# Old Town of Segovia and its Aqueduct (Spain)

## No 311bis

### 2 Issues raised

Map showing the boundaries of the proposed buffer zone

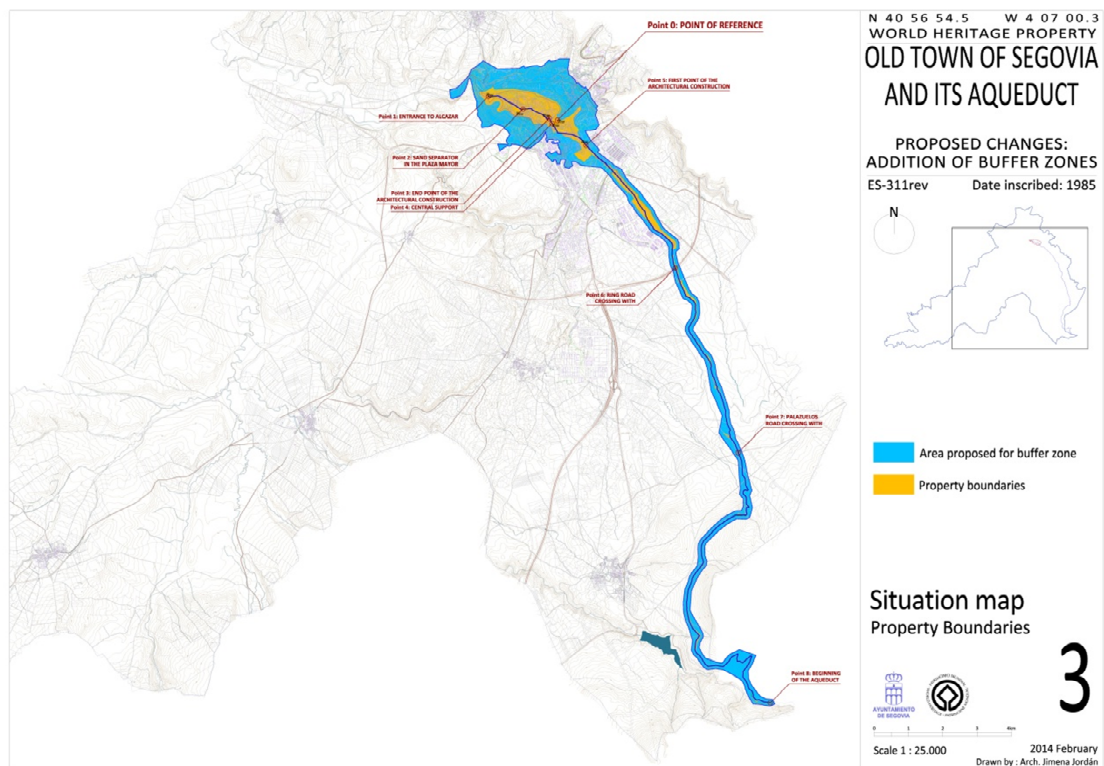
ICOMOS notes that no view analysis has been provided but considers that the photographic coverage is adequate.

ICOMOS commends the intention of the PEAHIS but notes that no details have been provided on how they protect the buffer zone in terms of height controls and protection of viewsheds.

ICOMOS considers that the proposed buffer zone is adequate but that more detail is required on how it will be protected.

ICOMOS recommends that the proposed buffer zone for the Old Town of Segovia and its Aqueduct, Spain be **approved**.

ICOMOS also recommends that the State Party submit, by 1 December 2015, a report to the World Heritage Centre outlining in detail how the buffer zone will be protected in terms of height controls and protection of viewsheds for examination by the World Heritage Centre and ICOMOS.
